# CITY OF PORTLAND, MAINE

Project Name: Stroudwater Preserve  
Address: 1700 Westbrook Street  
Applicant: Stroudwater Development Partners LLC  
Planner: Shukria Wiar, Planner

Project#:2017-193 and 2017-199 (Conditional Use)  
CBL: 229 A002001

# PLANNING BOARD REPORT PORTLAND, MAINE

Figure 3: Proposed Layout of Site and Landscaping

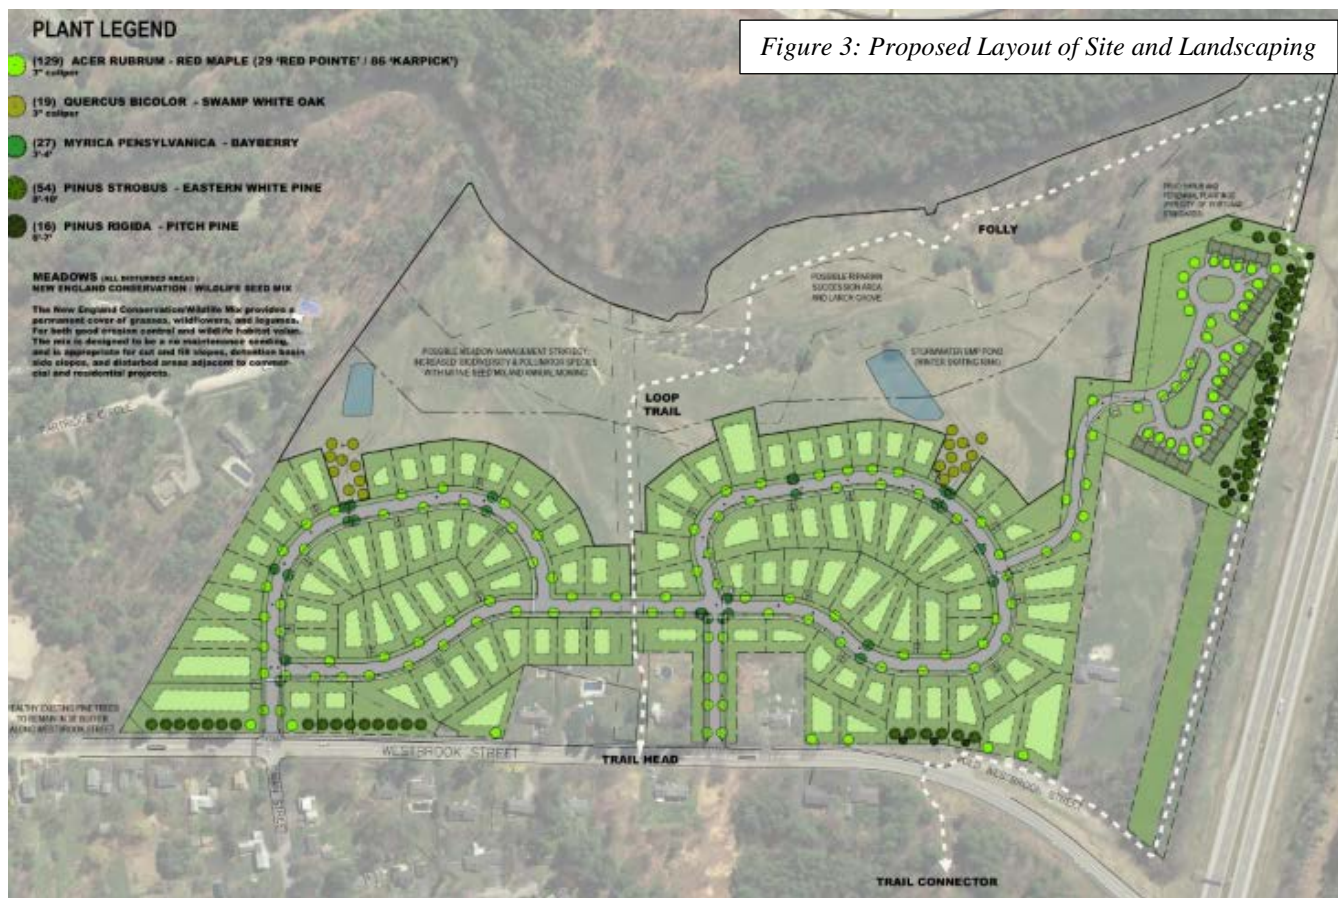
**b) Street Trees** - The tree and landscape plan lists out Red Maple and Swamp White Oak as street trees in the project. In reviewing this plan it might be sense to take a closer look at the actual tree placement locations.

Red Maples at mature size could fit between the street and sidewalk. The second tree type mentioned Swamp White Oaks mature size is too large to fit in the space between the street and sidewalk. Options could include setback planting behind the sidewalk and / or medium size trees vs large size trees.

**Street trees** - the project lists street sizes at 3" caliper, we know from experience that smaller 2" trees will adapt quicker due to less transplant shock. We would recommend 2" caliper street trees as a minimum size and the project could go to larger 3" trees if desired.

**Street tree per unit standard** - We would recommend to have at least a 1 tree per unit planting goal with some lots with limited frontages, utilities or street lights effecting spacing where applicable. The tree count below the standard could be planted along the 'open space' parcel as a compromise as this is somewhat unique subdivision with public land in addition to the street frontage.

**c) Conifers / Evergreen trees** - the project proposes to plant a mix of native White Pine and Pitch Pine in groves to create buffers. The tree sizes are listed at 6' - 7' height, we would recommend a mix of sizes to help make the trees look more natural vs all uniform sizes. That would include tree sizes 4 - 5', 5 - 6' and 7 - 8' height. The size mix should target the majority of trees near 6' when planted. The mix will also be easier to source in the landscape trade and have a better overall look. Additional native conifer types are acceptable - Red Pine, White Spruce, Red Cedar.
